ANSI/AHRI Standard 1350 (I-P) with Addendum 1

Mechanical Performance Rating of Central Station Air-handling Unit Casings

September 2015

Addendum 1 (dated September 2015) of ANSI/AHRI Standard 1350 (I-P)-2014, "*Changes to ANSI/AHRI Standard 1350 (I-P)-2014"* is provided as follows. The following changes have been incorporated (deletions are shown by ~~strikethroughs~~, additions are shown by shading) into the already published 2014 version of ANSI/AHRI Standard 1350 (I-P) to avoid confusion:

Figure C13. CSAHU with No Pressure Change Wall

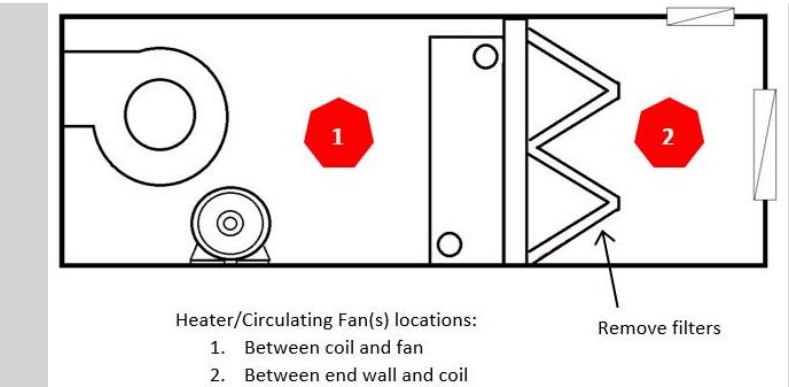
C7.1.1 The test shall be performed with distributed internal heat sources and circulating fans as needed to provide uniform internal temperatures. The heat source will be energized to provide a minimum of 30°F higher average internal air temperature when compared to external ambient temperature but the internal temperature should not exceed 120° F. The manufacturer shall specify the maximum temperature for testing if the product has a lower maximum allowable internal temperature than 120° F. Steady state is defined in Section C7.3.3. See Figures C13, C14, and C15 for some example thermal set-ups.

14) Added Figures C13, C14 and C15.
